**amt-2017-380**

**Author response to reviews**

Mok et al., “Comparisons of spectral aerosol absorption in Seoul, South Korea”

Anonymous Referee #3

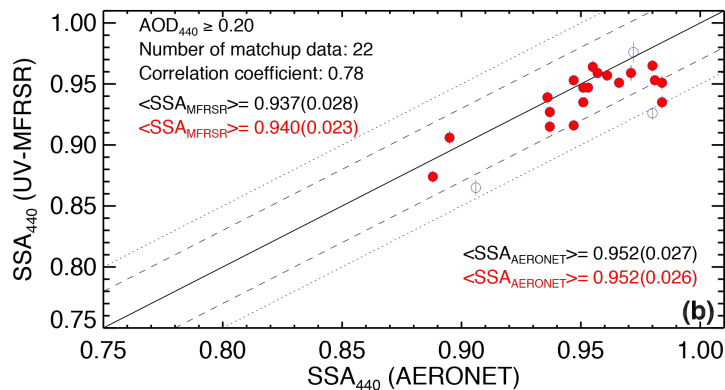
2. At page 7, the authors affirm that PSD retrievals from AERONET (which accounts for non-spherical aerosols) are used to calculate SSA from MFRSR assuming spherical particles. Isn't it an inconsistency? The authors should explain that most aerosol are spherical at the measuring site or that non-spherical aerosol were excluded from the analysis (e.g., based on some AERONET output parameters).

We acknowledge the inconsistency of assuming spherical particles in MFRSR retrievals. Below Figure shows similar comparison (Figure 3b) for cases with AERONET sphericity exceeding 95%. We see similar results but this leads to much smaller statistical sample size, not allowing us to compare with SKYNET SSA retrievals.
